## **ADDENDUM NO. 4:**

Date: July 7, 2015  
Project: Alberta Technology Center  
Owner: The City of Tuscaloosa  
Owner's Project No: A15-0513  
Architect: Ward Scott Architecture, Inc.

This Addendum forms a part of the Contract Documents and modifies the original Bid Documents dated June 22, 2015, as noted below.

5 ELEVATION - PRESENTATION NICHE (2 TOTAL)  
3/8" = 1'-0"

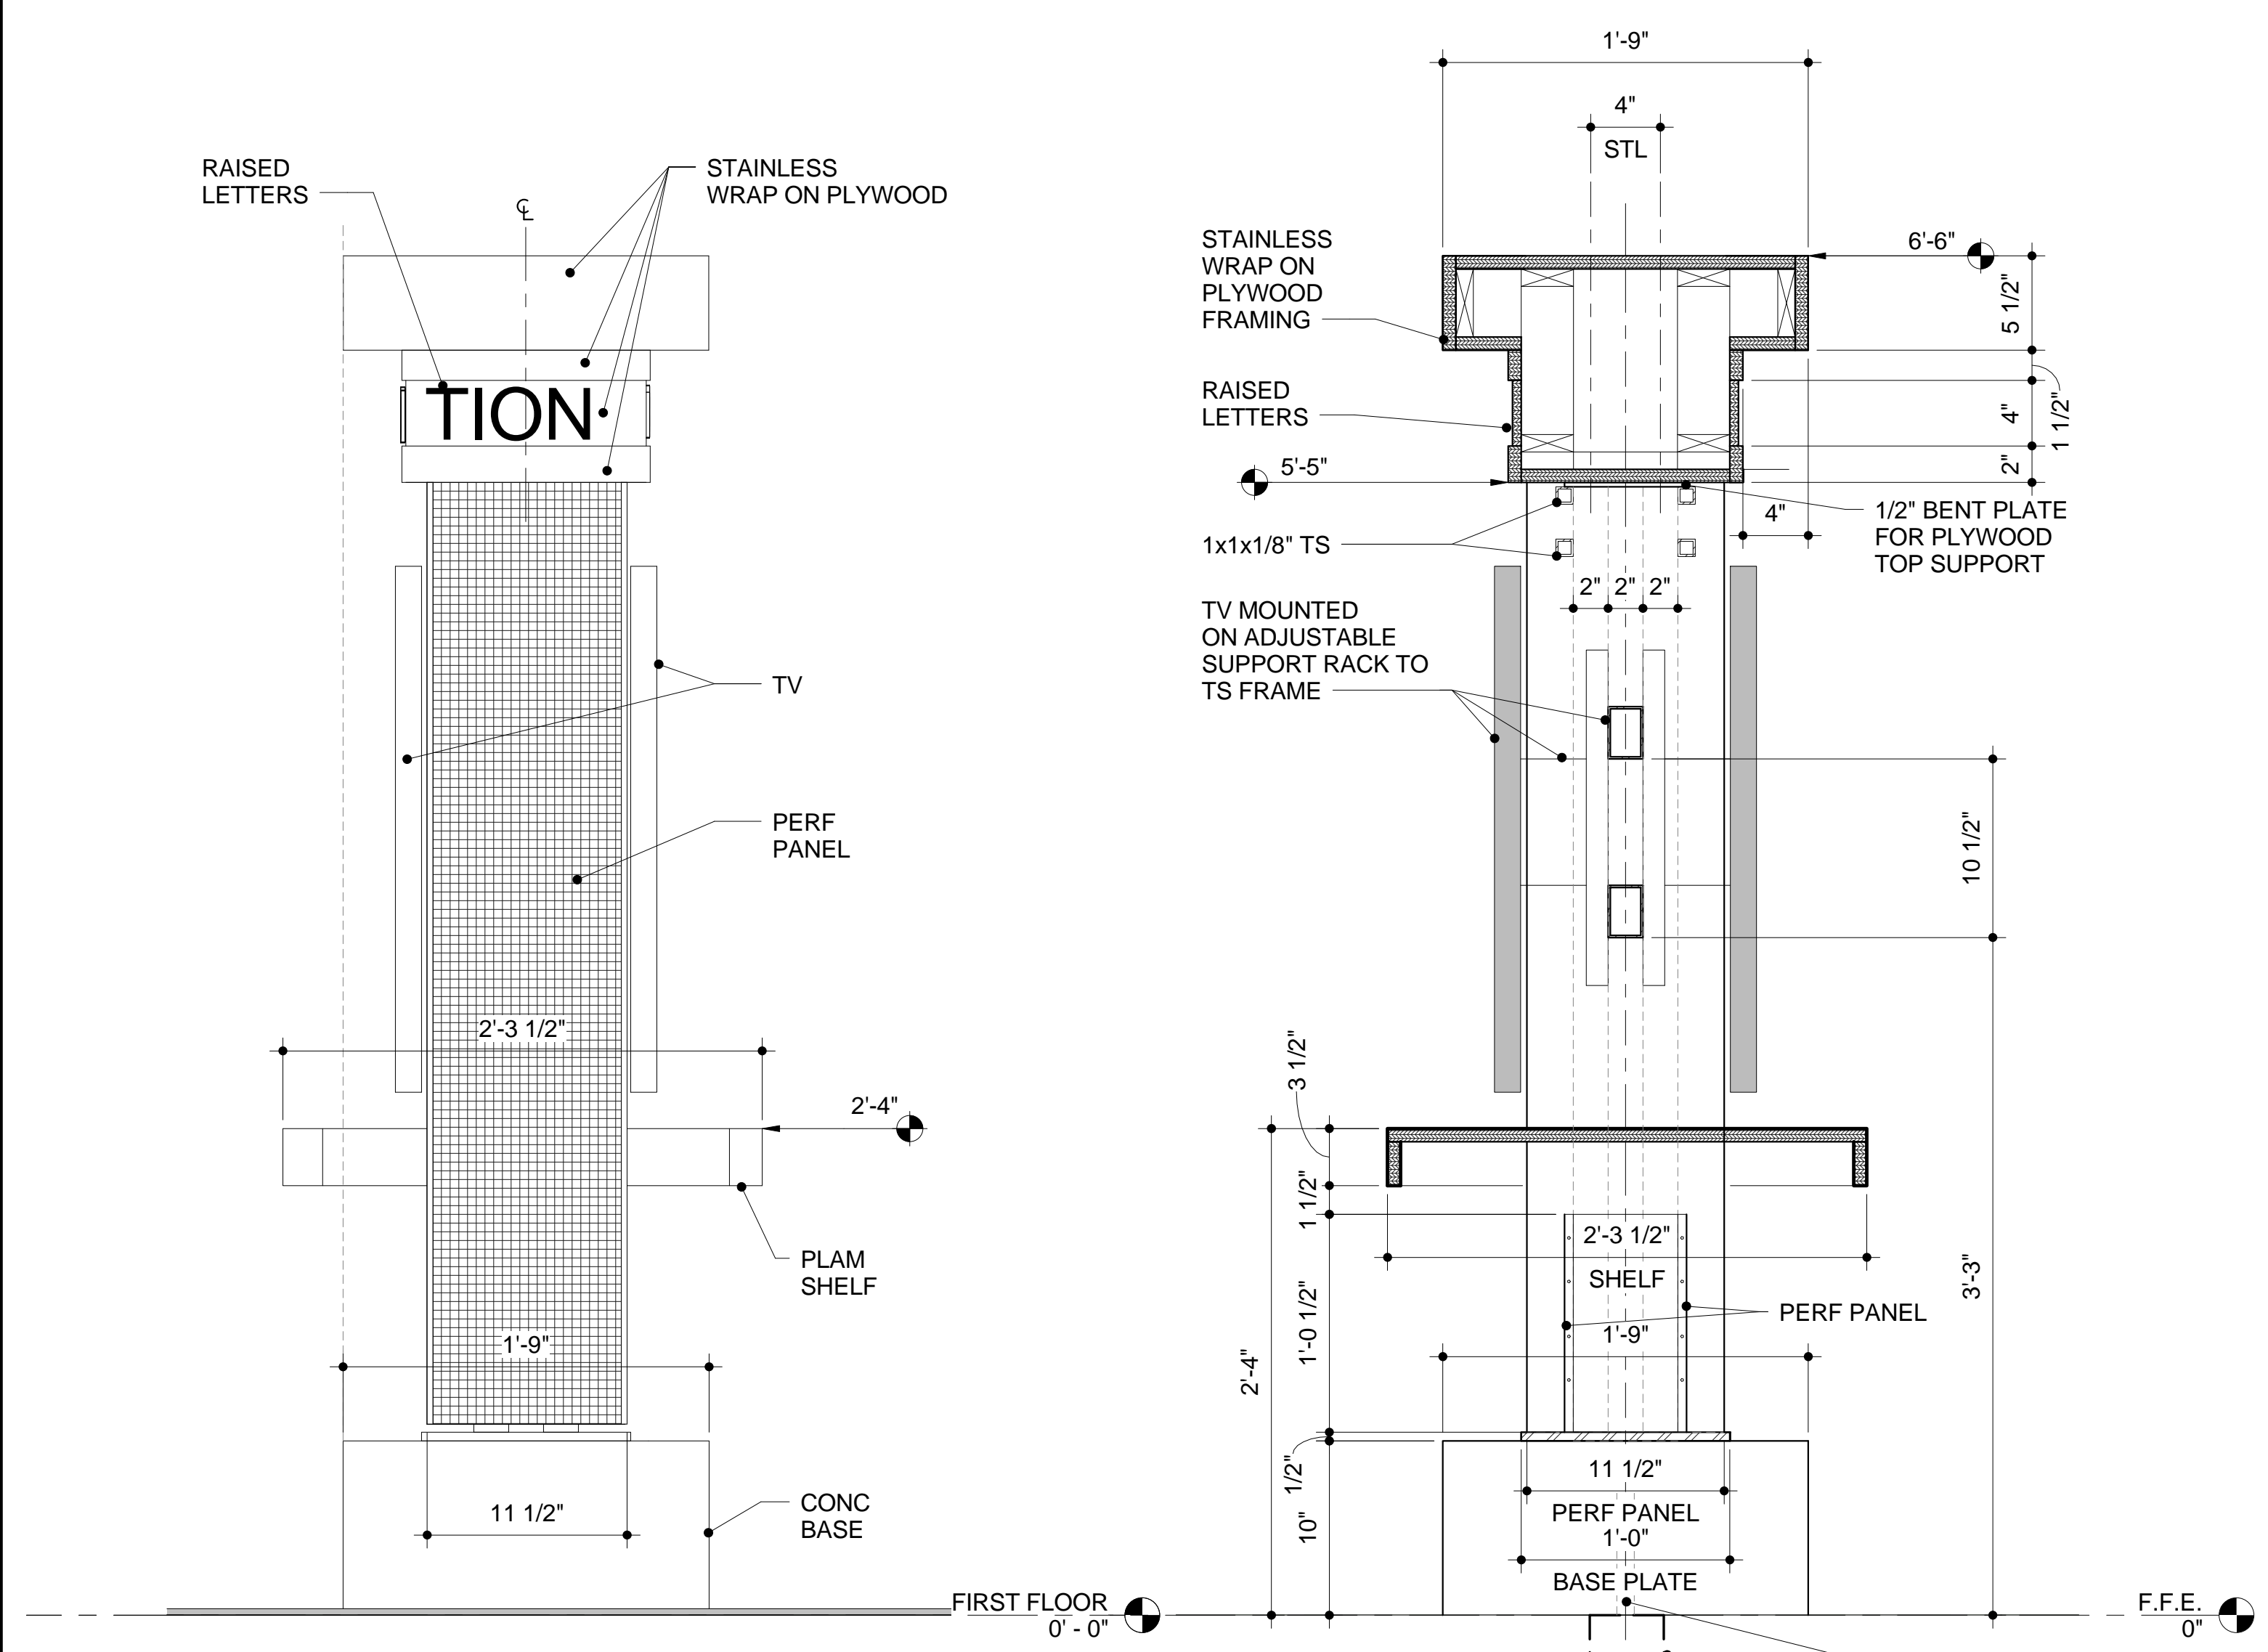
- A. The following sheets have been added:
  - 1. Sheet A502 Upper Reflected Ceiling Plan
  - 2. Sheet A702 Interior Kiosk and Details
- B. The following sheets have been modified:
  - 1. A101 Floor Plan.
    - a. Two presentation niches have been added at Vest 101 – See elevation on 3/A702. Note additional electrical puck fixtures and switches by engineer during submittals. Puck Basis of Design: Modalight, Mezo3.
    - b. Add General Note: install 10 corner guards per Architect.
  - 2. A101 Equipment Plan. Item 17 Interactive Video Wall to be purchased by (OWNER-IT), not by GC as previously indicated.
  - 3. A701 Exterior Signage. New Aluminum plate emblem added to hole in south canopy.
